Re: Product Change Notification for Harwin packaging.

Please be advised that the pick and place cap used on male Datamate connectors (M80 Series) has been changed from a metal stamped cap to a plastic cap. This has been identified and implemented as part of our continuous improvement program at Harwin. The visual difference is as follows:

Left = New plastic cap, Right = Previous metal cap

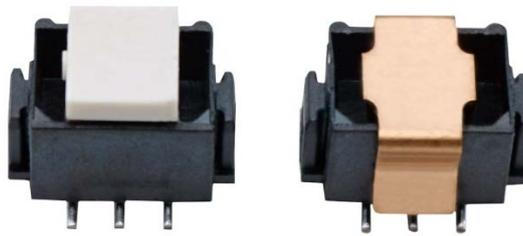
As you can see from the profile of the plastic cap, a small amount of additional height has been introduced, and changes to the settings on your pick and place machines may be required. Please also note, we use a selection of materials for the plastic cap which will result in either natural or black plastic, depending on availability.
